ADDENDUM NO. 5 TO PROJECT NO. 44362

**PROVIDE COMBINED SUPPORT MAINTENANCE SHOP
516 – ROUTE 216
STORMVILLE, NEW YORK 12582**

August 16, 2013

DWG NO.:
C-160.1

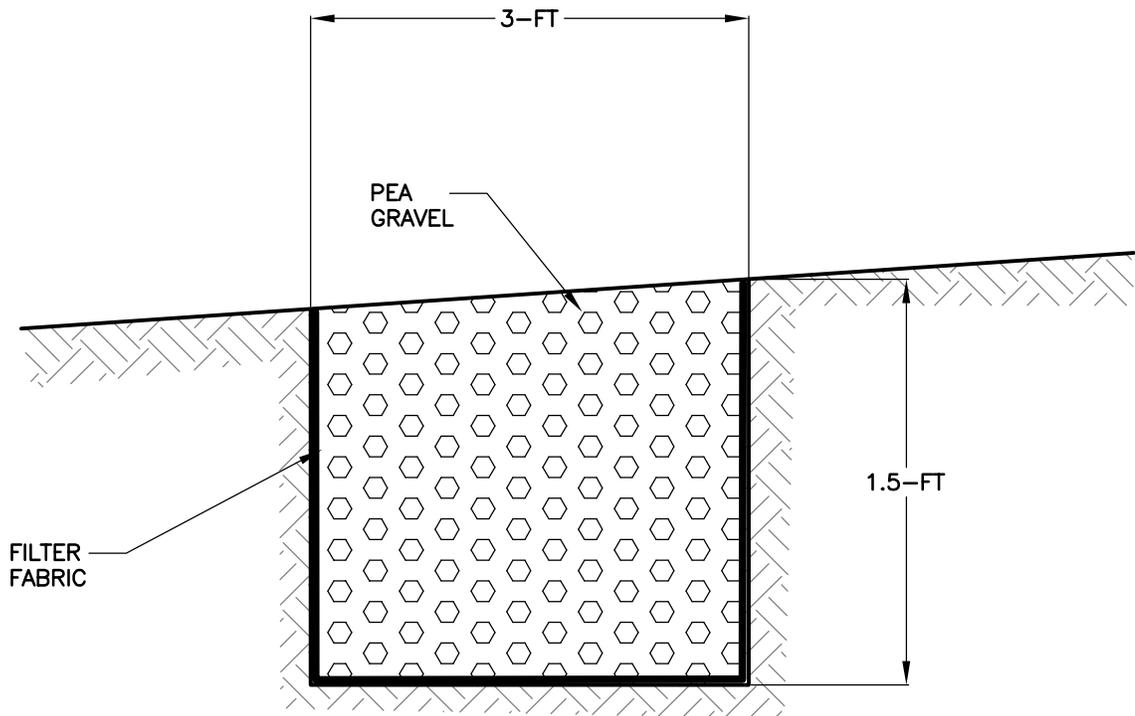
2. 015813 PROJECT IDENTIFICATION SIGN: Add paragraph 3.03 as follows:

“3.03 PROJECT SIGN

- A. Refer to attached drawing C-160.1 Project Sign”

DWG NO:
C-533A

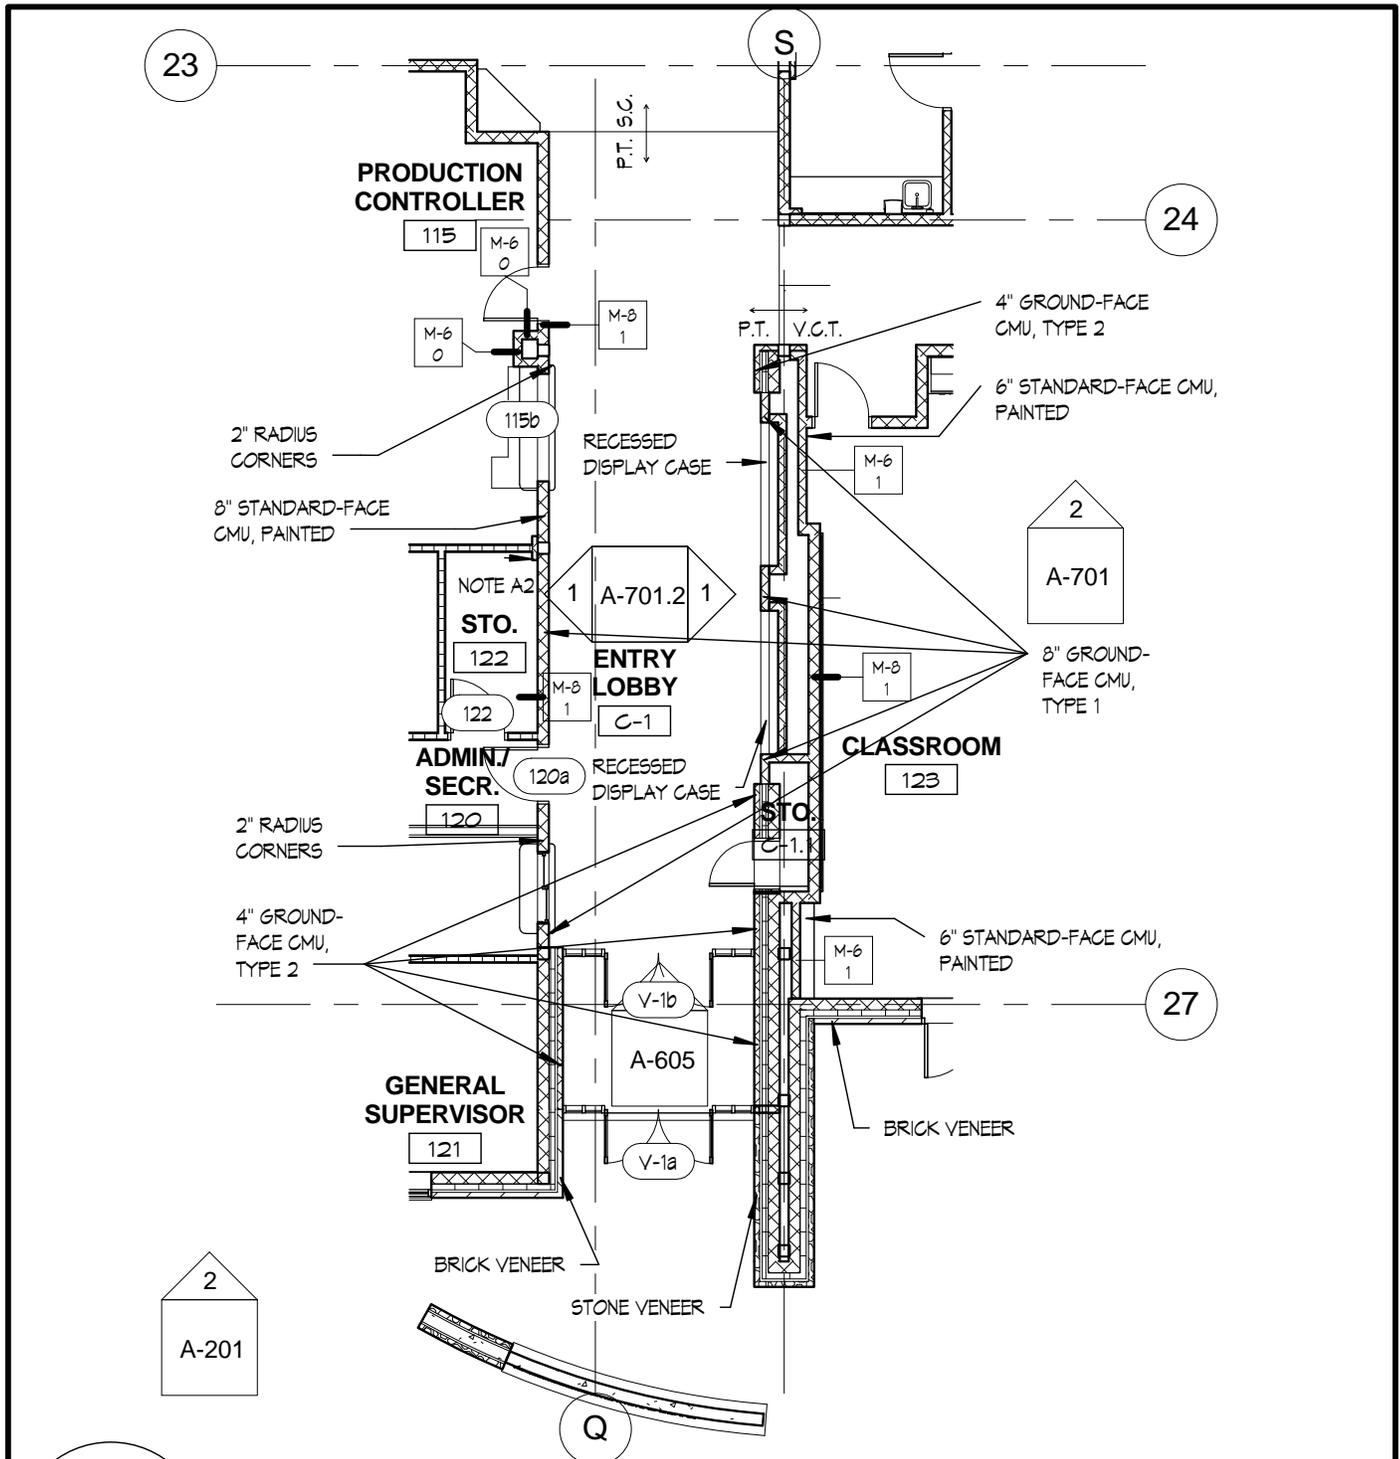
- 5. Addendum Drawing:
 - a. Drawing No. C-533A, accompanies this Addendum and forms part of the Contract Documents. Drawing includes detail for “Stone Diaphragm”.

DWG NO:
A400.1

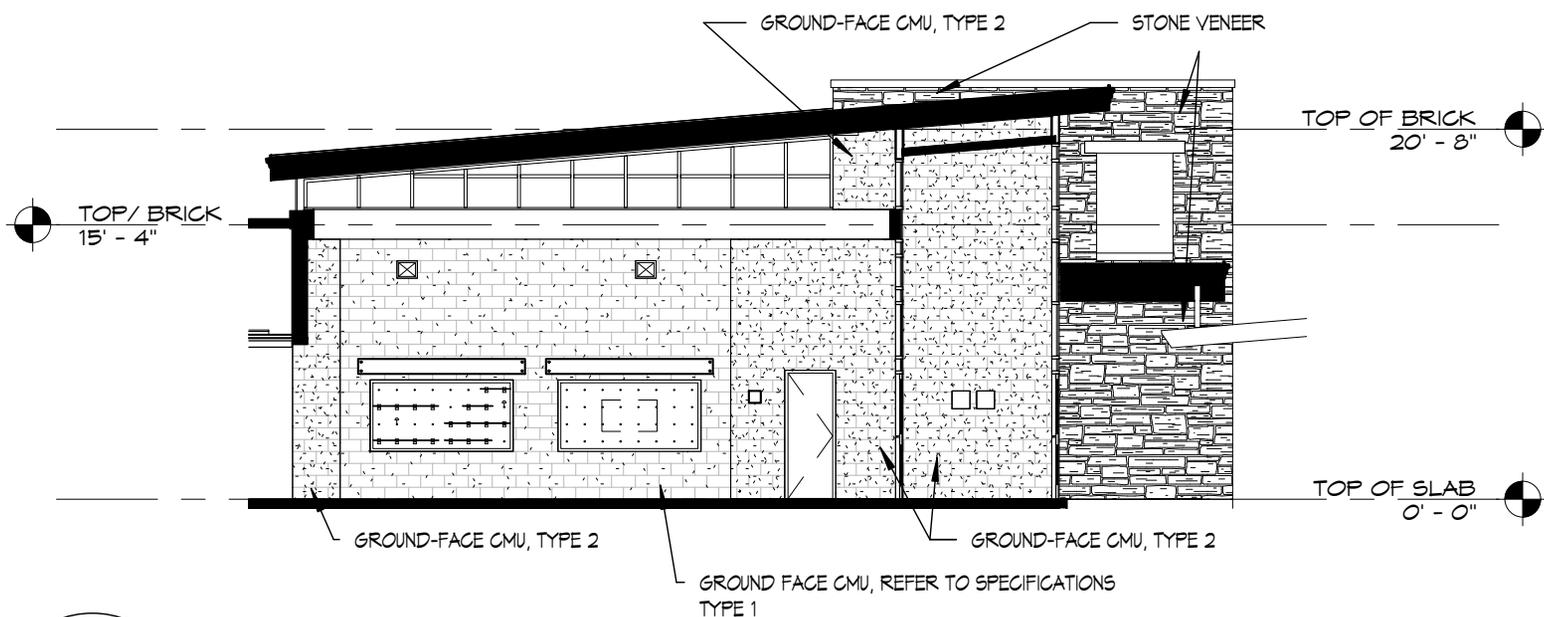
- 6. Addendum Drawings:
 - a. Drawing No. A-400.1, dated 08/07/13, accompanies this Addendum and forms part of the Contract Documents. This drawing revises the masonry wall finishes noted on ENLARGED FLOOR PLAN-FRONT ENTRY 4/A-400.

DWG NO: **A701.1**

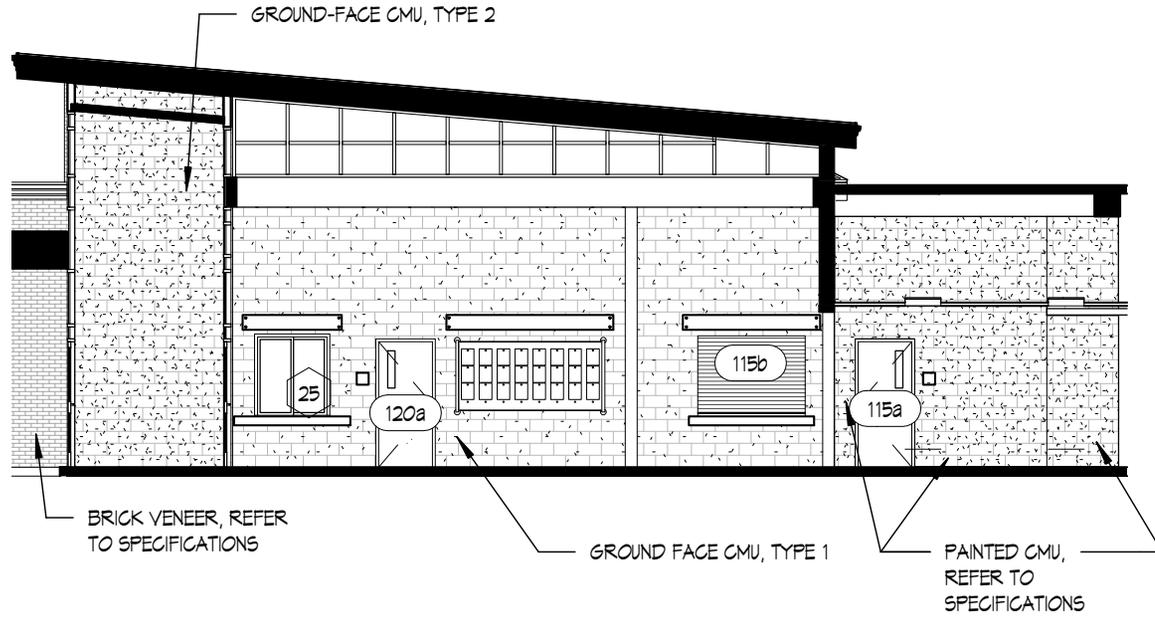
- b. Drawing No. A-701.1, dated 08/07/13, accompanies this Addendum and forms part of the Contract Documents. This drawing revises the masonry wall finishes noted on WEST ELEVATION - LOBBY 5/A-701.
